Re: **ADDENDUM No. 1**
NEW FT. WHITE BRANCH LIBRARY
AAA Project No. 0906

Please note the following changes to the Specifications and Drawings:

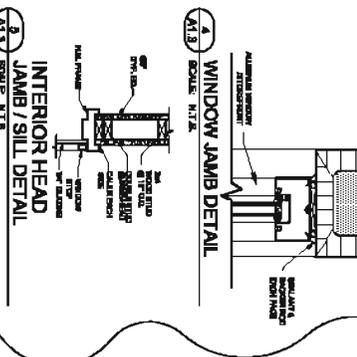
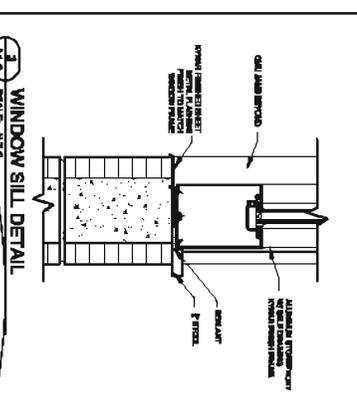
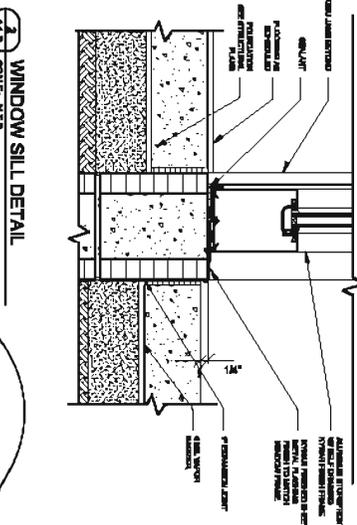
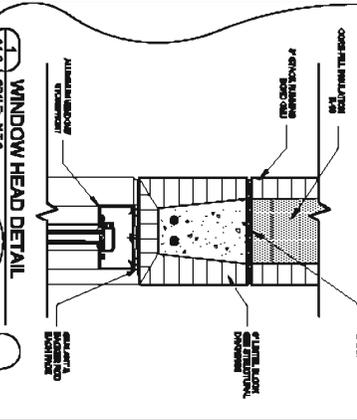
7. Drawing Sheet A1.0: See attached SK-1 for placement/swing changes to doors 106, 109 & 110; and revision to construction note #3.
8. Drawing Sheet A1.1: See attached SK-2 for revisions to door #101's door type, door material, and frame material. Doors 100 & 101A's bottom stile profile and sill detail to be per manuf. Std.

1. PROVIDE INSULATED & TEMPERED GLASS AT ALL EXTERIOR GLAZING UP TO 8' A.F.F.
2. PROVIDE 1/4" TEMPERED GLASS AT ALL INTERIOR GLAZING UP TO 6' A.F.F., U.N.O.
3. PROVIDE CLEAR FINELITE AT ALL INTERIOR FINISHED OPENINGS
4. FRAME SIZES MAY VARY BETWEEN MANUFACTURERS. ADJUST GLAZING DIMENSIONS TO MATCH SPECIFIC MANUFACTURER PER SHOP DRAWING PROCEDURE.
5. ALL ALUMINUM FINISHES SHALL BE "PAINT" IN A RANGE OF AVAILABLE STAINLESS COLORS.
6. ALL EXTERIOR GLAZING SHALL BE TINTED AND ADJUST GLAZING DIMENSIONS TO MATCH SPECIFIC MANUFACTURER PER SHOP DRAWING PROCEDURE. COLOR TO BE SELECTED BY OWNER FROM A RANGE OF AVAILABLE STAINLESS COLORS FOR OWNER'S SELECTION.

Sketch No.: SK-4
Ref. Sht. No.: A2.2

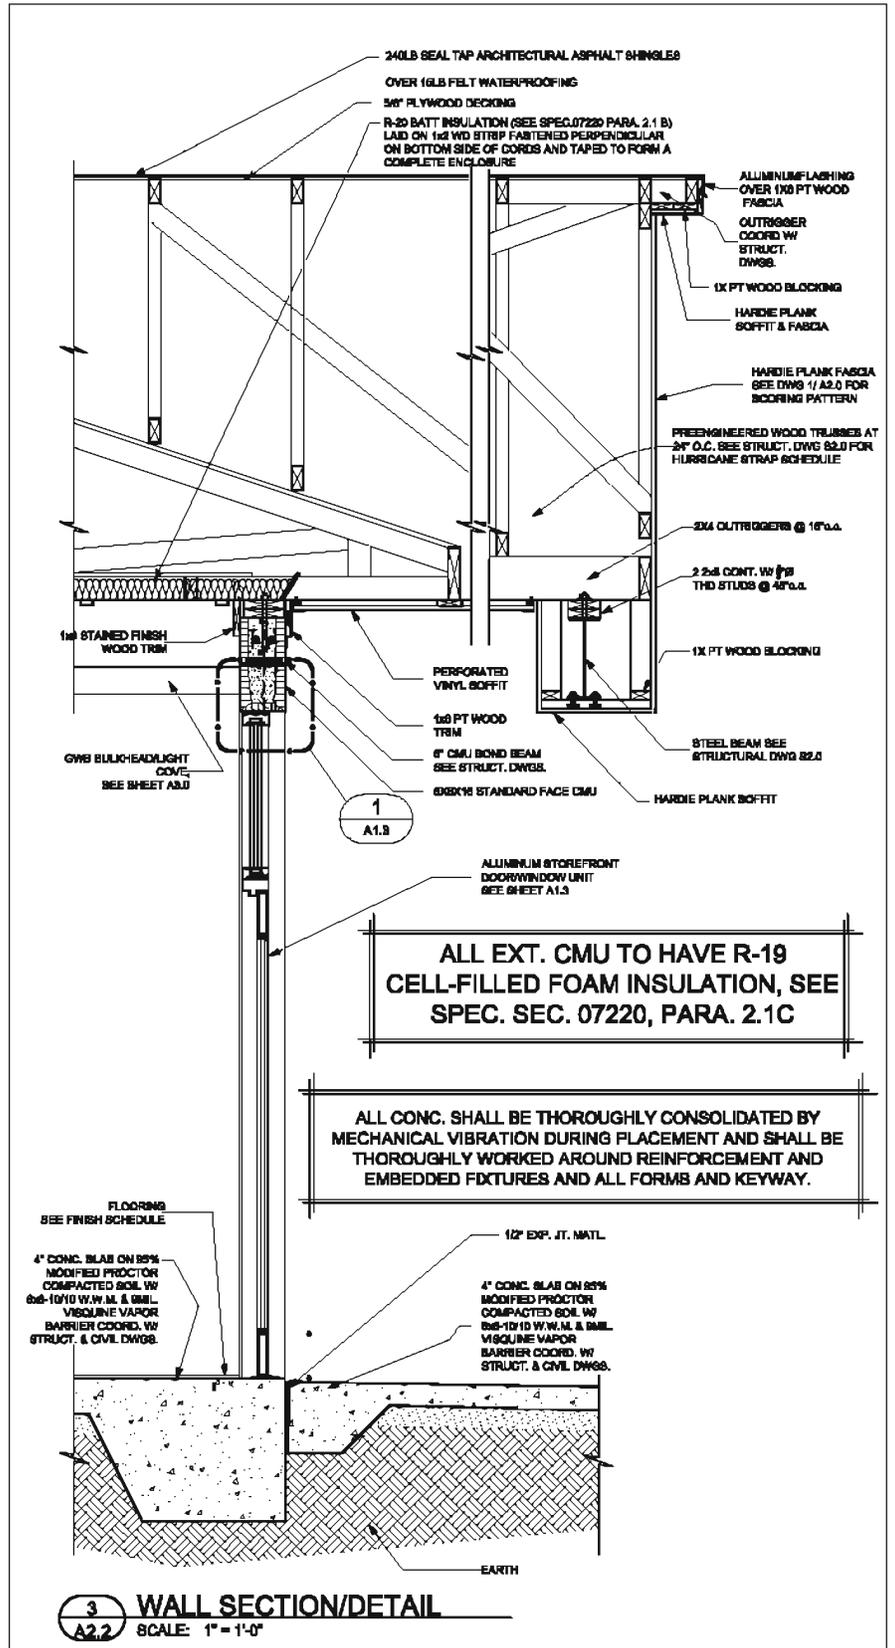
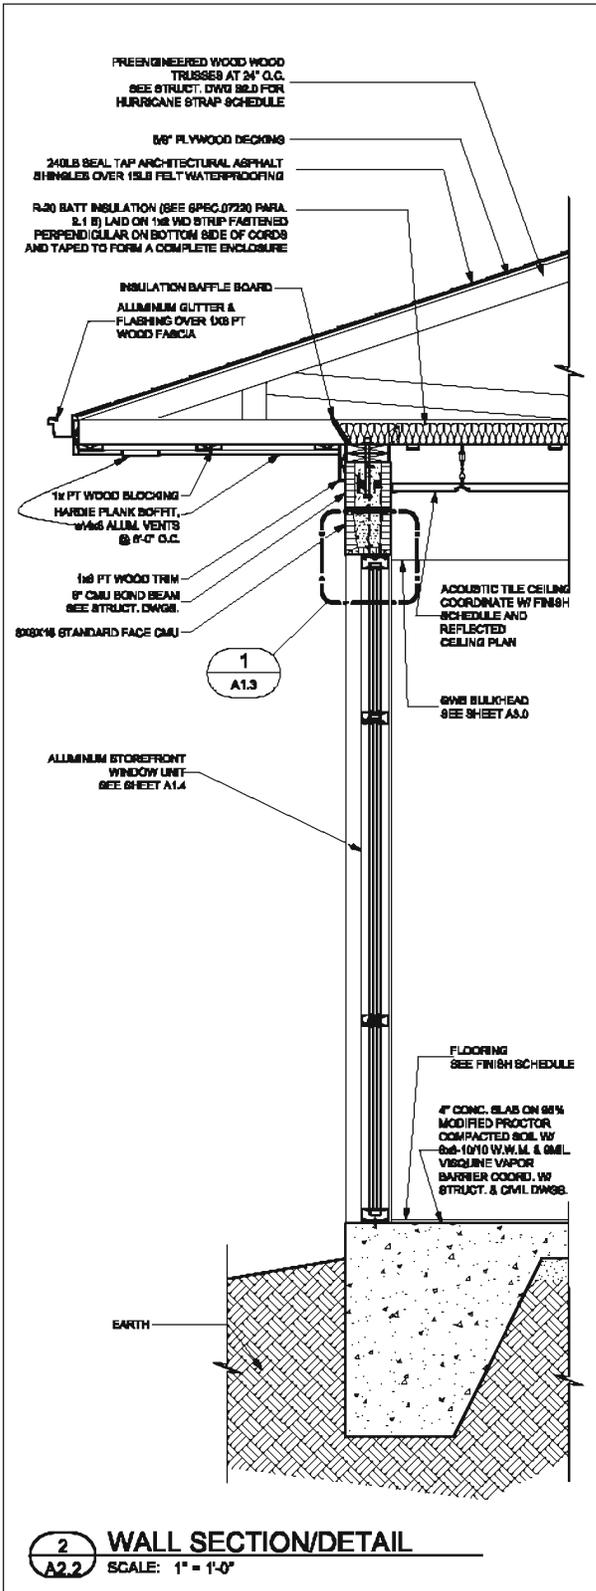
10. Drawing Sheet A1.3: See attached SK-3 for note #5 and sht. # revisions.
11. Drawing Sheet A2.2: See attached SK-4 for section notations and sht. # revisions.

NOTE: REVISIONS SHOWN HERE
ALSO APPLIES TO SEC.
1/A2.2

Sketch No.: MSK-3
Ref. Sht. No.: M1.1

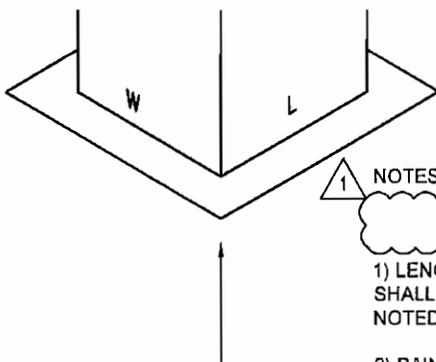
15. ALL DUCT DIMENSIONS SHOWN ARE INTERIOR CLEAR. ALLOW FOR LINER. ALL DUCTWORK SHALL BE LOCATED BELOW ROOF INSULATION.

16. ALL DUCTWORK SHALL BE GALVANIZED STEEL WITH 2" INSULATION STAPLED, TAPED AND MASTIC. MAIN TRUNKS, EXHAUST AND OUTSIDE AIR DUCTWORK SHALL BE GALVANIZED STEEL. ALL BENDS GREATER THAN 45 DEGREES SHALL HAVE TURNING VANES. CONTRACTOR SHALL VERIFY ALL CLEARANCES AND ADJUST FOR FIELD CONDITIONS PRIOR TO CONSTRUCTING ANY DUCTWORK. ALL DUCT SIZES ARE CLEAR INSIDE DIMENSIONS. INSTALL ALL DUCTWORK PER APPROPRIATE SMACNA STANDARD.

17. TRUNK DUCT SHALL EXTEND AT LEAST 6" BEYOND THE LAST BRANCH DUCT TAKEOFF.

18. ALL TRANSITIONS SHALL BE MADE WITH A SLOPE NOT EXCEEDING 1 TO 4.

19. ANY FLEXIBLE DUCT SHALL BE STRETCHED OUT, INSTALLED, AND HUNG SO AS TO PRODUCE A STRAIGHT SMOOTH AIR PATH WITH LESS THAN 5" SAG IN 10 FEET. SUPPORT DUCT WITH ADEQUATE HANGERS AT EVERY 10 FEET. UNNECESSARY BENDS, SAGS, TWISTS, ETC. WILL NOT BE ALLOWED.

20. ALL FLEXIBLE DUCT CONNECTIONS TO THE DIFFUSERS AND GRILLES SHALL USE FABRICATED METAL TRANSITION PIECES. ALL CONNECTIONS SHALL BE INSULATED, TIE-WRAPPED, TAPED AND MASTIC.

21. ALL BRANCH TAKE-OFFS TO BE PROVIDED WITH MANUAL VOLUME DAMPERS. ALL ELBOWS AND TEES MUST BE FURNISHED WITH TURNING VANES. PROVIDE MANUAL VOLUME DAMPERS WITH EXTRACTOR AT ALL FLEX TAKE-OFFS.

Sketch No.: MSK-2

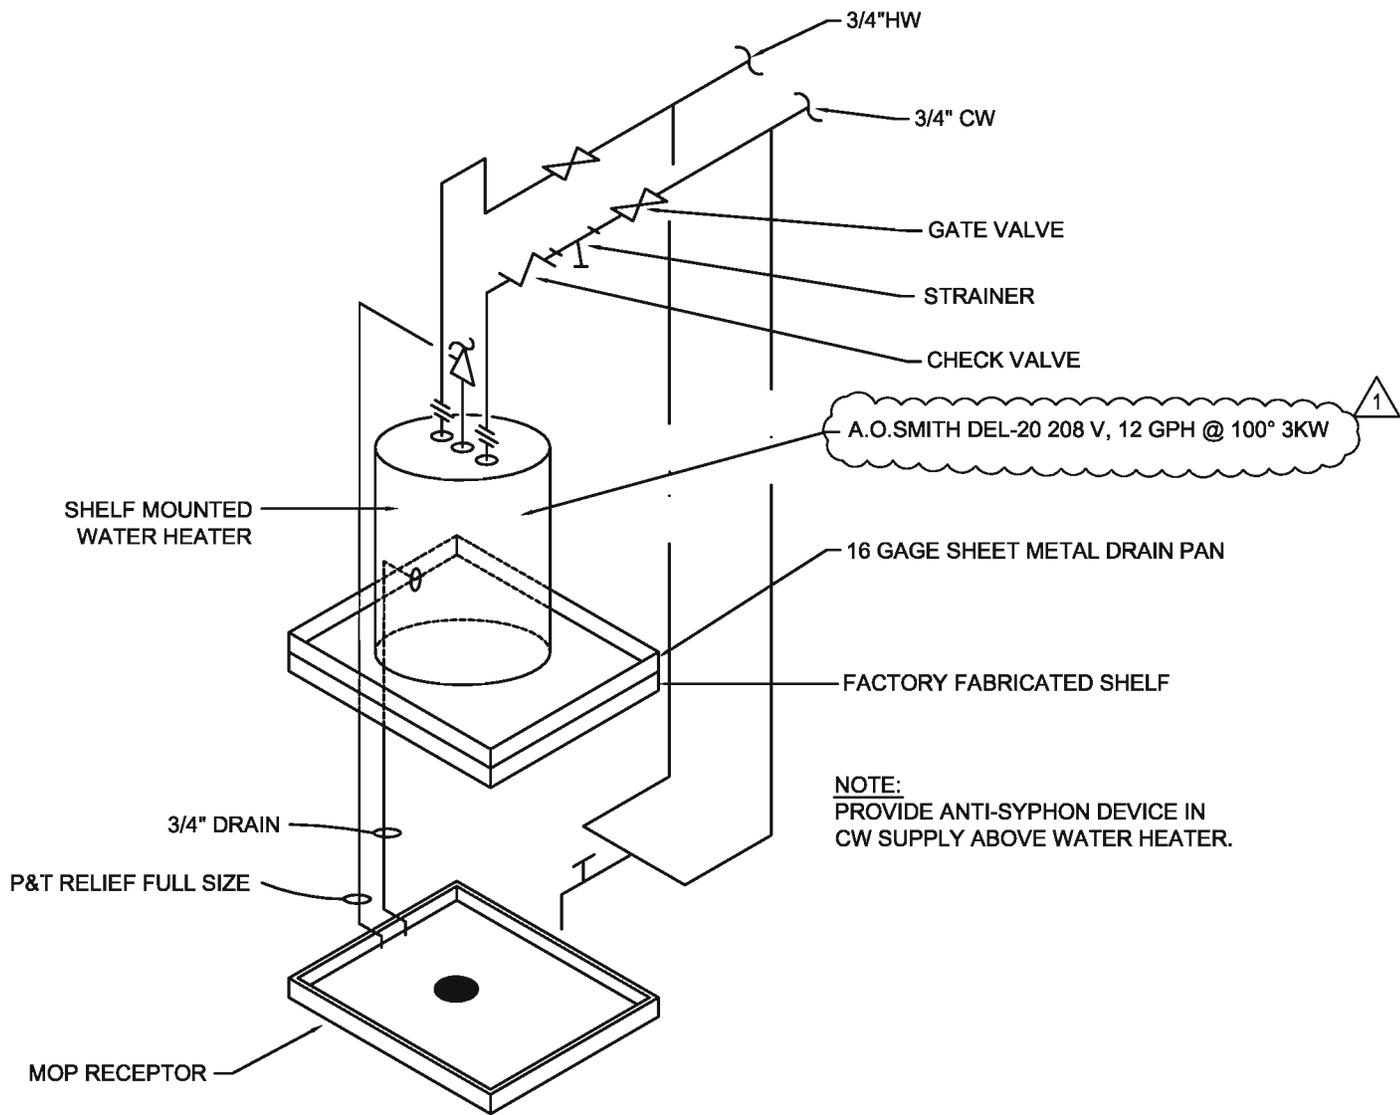
SHELF MTD. WTR. HTR. DETAIL ABV. MOP SINK
